Re: Comprehensive Cardiovascular Consultants
NRC License 24-32459-01
Control No. 316317

Per your attached facsimile received this morning, we are providing the additional information you requested to review our request for facility close out at 3844 South Lindbergh Blvd., Suite 250, St. Louis, MO.

Comprehensive Cardiovascular Consultants, Inc.**Decommissioning Survey of site: 3844 S. Lindbergh Blvd, Suite 250, Sunset Hills, MO 63127****May 29, 2007 at 14:30****by: A. Ganter, NC Systems, Inc.**

LOCATION: Regarding Comprehensive Cardiovascular Consultants (NRC License 24-32459-01) St. Louis, Missouri- Close Out Survey for the "old" facility located at 3844 South Lindbergh, Blvd., Suite 250, St. Louis, Missouri.

PARTIAL PLAN - NUCLEAR CAMERA

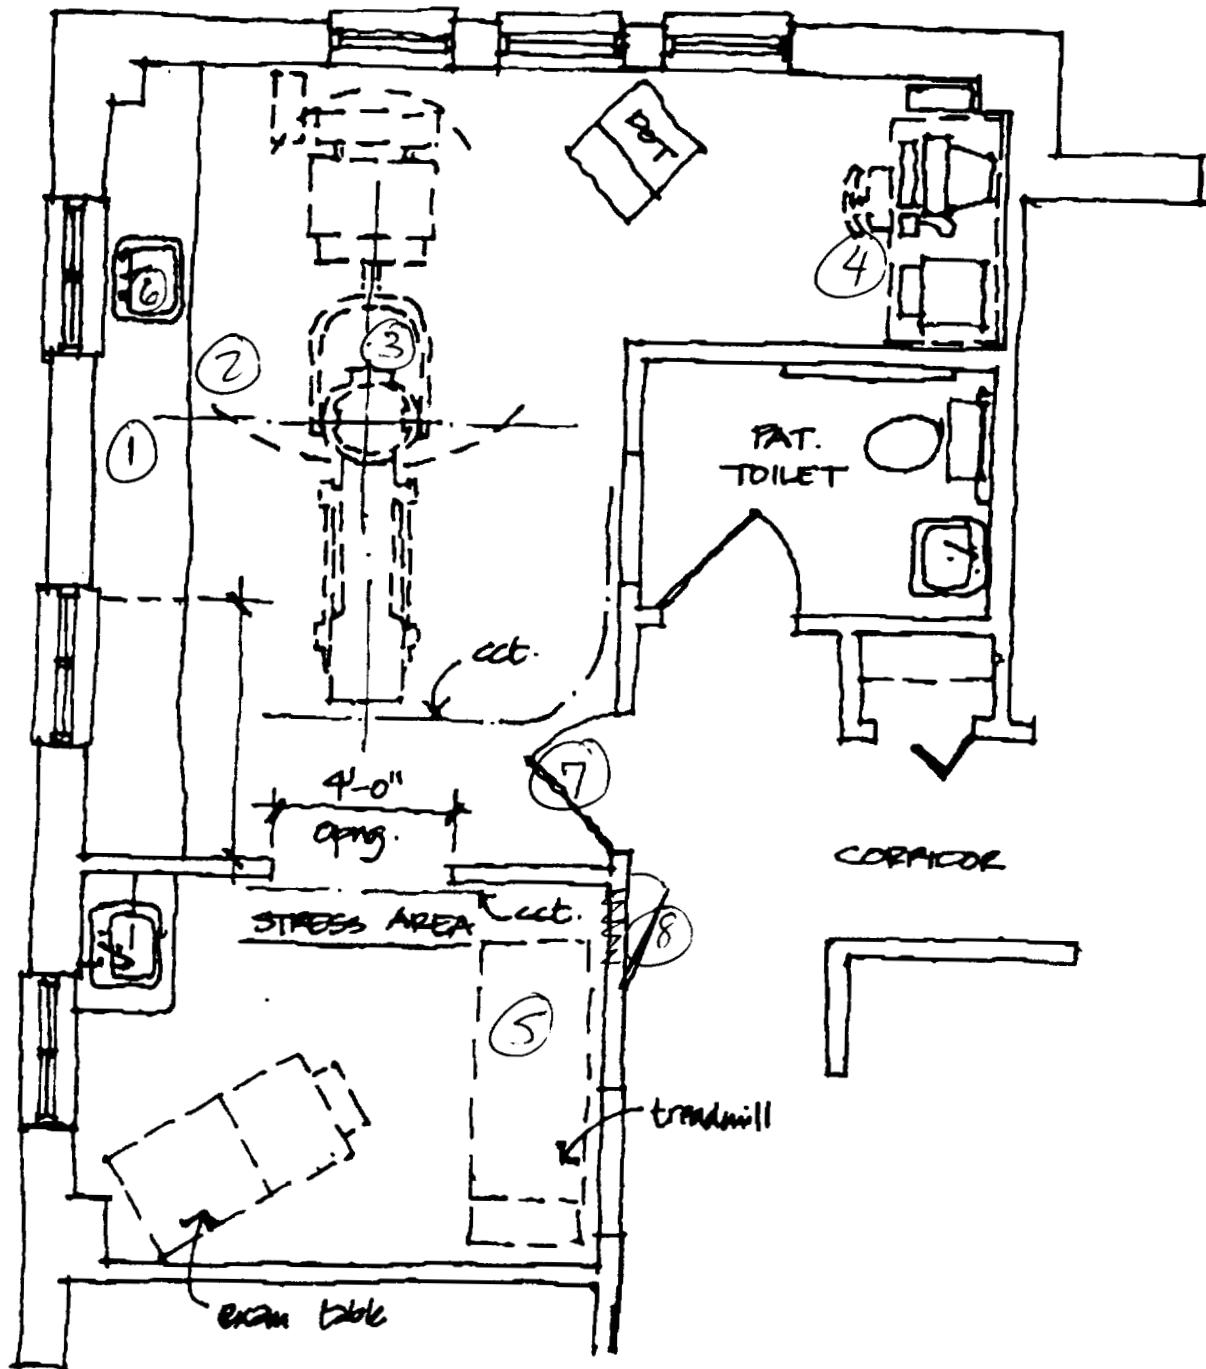
3. Please submit a sketch of the "old" facility located at 3844 South Lindbergh, Blvd., Suite 250, St. Louis, Missouri, with the G-M survey and wipe test results keyed to specific locations on the sketch.

1. The only "unsealed" sources used at the site were ^{99m}Tc and ^{210}Tl . None of these radionuclides were present at close-out. No ^{131}I in the form of NaI was present in the facility. See the inventory attached.
2. The Sealed Source Leak Test and Inventory, dated 6/6/07, (Attachment 2-a), is a copy of the leak test results that were current at the time of the close-out survey for the sealed sources used or stored at the said facility. Attachment 2-b shows additional leak test results performed Oct. 01, 2003, as the only other historical reference data.
3. Attachments 3a and 3b provide a sketch of the facility with G-M and wipe test results keyed to the specific locations on the sketch.
4. The instrument used to perform the wipe tests is the Atomlab 450.

Background reading: 0.02 mR/hrSurveys and Wipe locations:Survey reading*

1 Hot Lab Counter	0.02 mR/hr
2 Hot Lab Floor	0.02 mR/hr
3 Camera Area	0.02 mR/hr
4 Computer Area	0.02 mR/hr
5 Treadmill Area	0.02 mR/hr
6 Hot Lab Sink	0.02 mR/hr
7 Imaging Room Door	0.02 mR/hr
8 Stress Lab Door	0.02 mR/hr
